MODIFICATION #2
WEST LILAC ROAD OVER I-15 BRIDGE
DEPARTMENT OF PUBLIC WORKS

**Request for a
Modification to a Road Standard
and/or to Project Conditions**

Project Number: TM 5571/5572 Date of Request: Sep. 12, 2012

ATTACHMENT 1

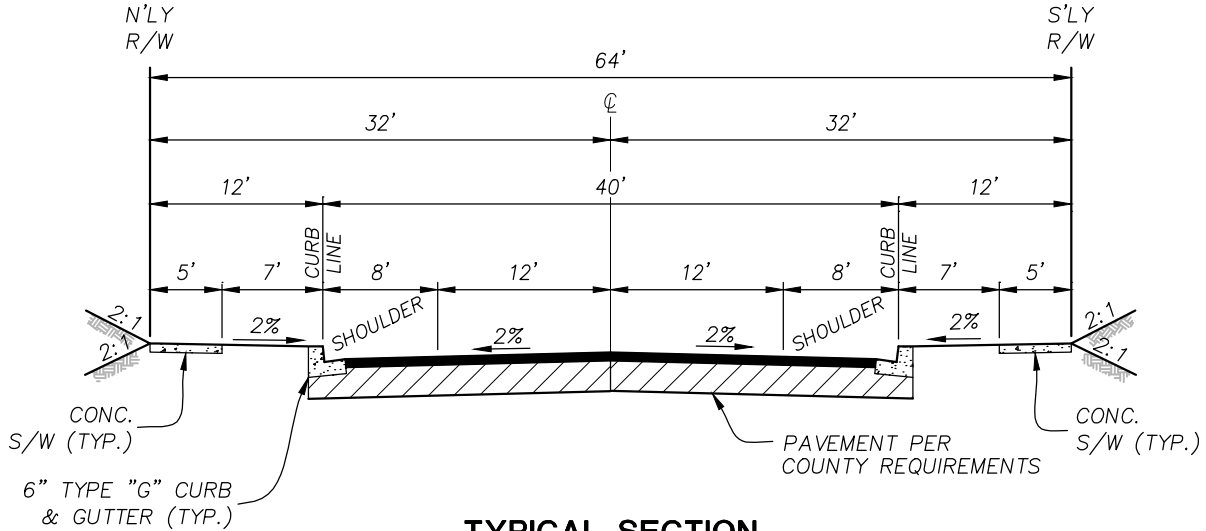
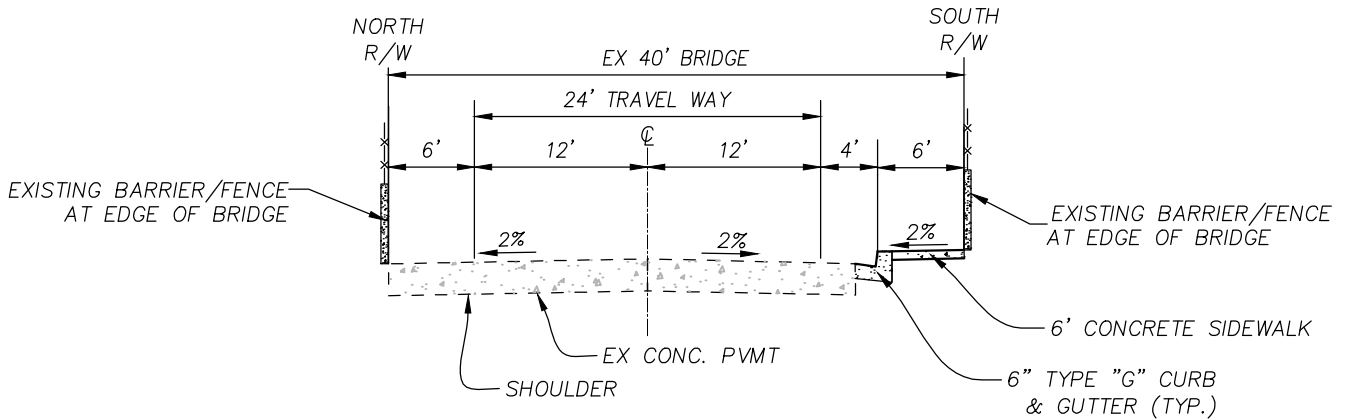
The standard road section for Light Collector Road 2.2C is 40'-54' wide curb to curb
width on 64'-78' r/w with a minimum design speed of 40 mph. The requested modification
to the road standard is to require no widening of the existing 40' wide West lilac Road
bridge over I-15 and allow only re-striping and the addition of curb, gutter and sidewalk
on one side of the road (see attachment 1).

The existing 40' wide bridge section has a 24' travel way with 8' shoulders on each
side. A proposed widening of the bridge would be extremely expensive, extremely
disruptive to anyone that uses West Lilac Road & I-15, and would alter the beauty and
historic nature of the bridge (see attachment 2). The modified road would also allow
for safer pedestrian traffic over the bridge.
